Intersection ID: 18832	Main Street: SENECA_PL	Cross Street: VALLEY_STREAM_RD	Location:	SW
ADA ID: BEF4C2ED90EE	Ramp Type: ParaDiag	Initial Pass/Fail: Fail	Overall Compliance: No	Severity Score: 13.75

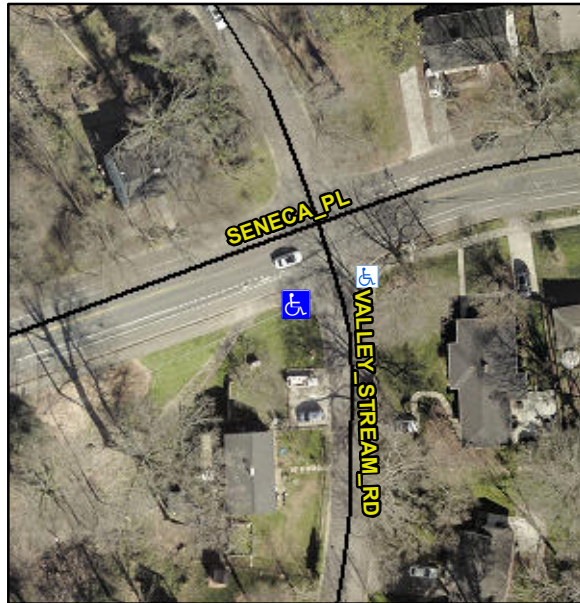
R304.3.2, R304.5.3

Compliance	Description	Data	Compliance	Description	Data
N/A	Ramp Length LT (in)	36.0	N/A	Ramp Length RT (in)	55.0
Yes	Ramp Width LT (in)	77.0	Yes	Ramp Width RT (in)	74.0
No	Ramp Slope LT (%)	10.9	Yes	Ramp Slope RT (%)	6.2
No	Ramp XSlope LT (%)	4.3	No	Ramp XSlope RT (%)	4.2
N/A	Landing Length (in)	N/A	N/A	DWS Provided?	N/A
N/A	Landing Width (in)	N/A	N/A	DWS Contrast?	N/A
N/A	Landing Slope (%)	N/A	N/A	DWS Length (in)	N/A
N/A	Landing X Slope (%)	N/A	N/A	DWS Full Width?	N/A
N/A	Landing Curb? (Y/N)	N/A	N/A	DWS Offset (in)	N/A
N/A	Shared Landing?	N/A			
N/A	Gutter Ponding?	N/A	N/A	Gutter Slope (%)	N/A
N/A	Gutter Lip Ht (in)	N/A	N/A	Gutter X Slope (%)	N/A
N/A	Painted X Walk1?	No	N/A	Painted X Walk2?	No
	X Walk 1 Direction	To E		X Walk 2 Direction	To N
N/A	X Walk 1 Width (in)	N/A	N/A	X Walk 2 Width (in)	N/A
	X Walk 1 Slope (%)	13.5		X Walk 2 Slope (%)	4.2
	X Walk 1 X Slope (%)	0.4		X Walk 2 X Slope (%)	13.3
N/A	Ramp inside XWalk1?	N/A	N/A	Ramp inside XWalk2?	N/A

Road Slope (%)	7.3	N/A	Clear Space?	N/A
	Road X Slope (%)	12.3	N/A	Clear Space to XWalk (in)	N/A
N/A	Any Obstructions?	N/A	N/A	Storm Grate/Utility Hazard?	N/A
	Obstruction Type			Storm Grate/Utility Type	
		N/A			N/A
			Yes	Surface Condition? (G/P)	Good
			N/A	Curb Slope (%)	13.9

Remove & Replace Curb Ramp With Two New Directional Ramps or Equivalent.
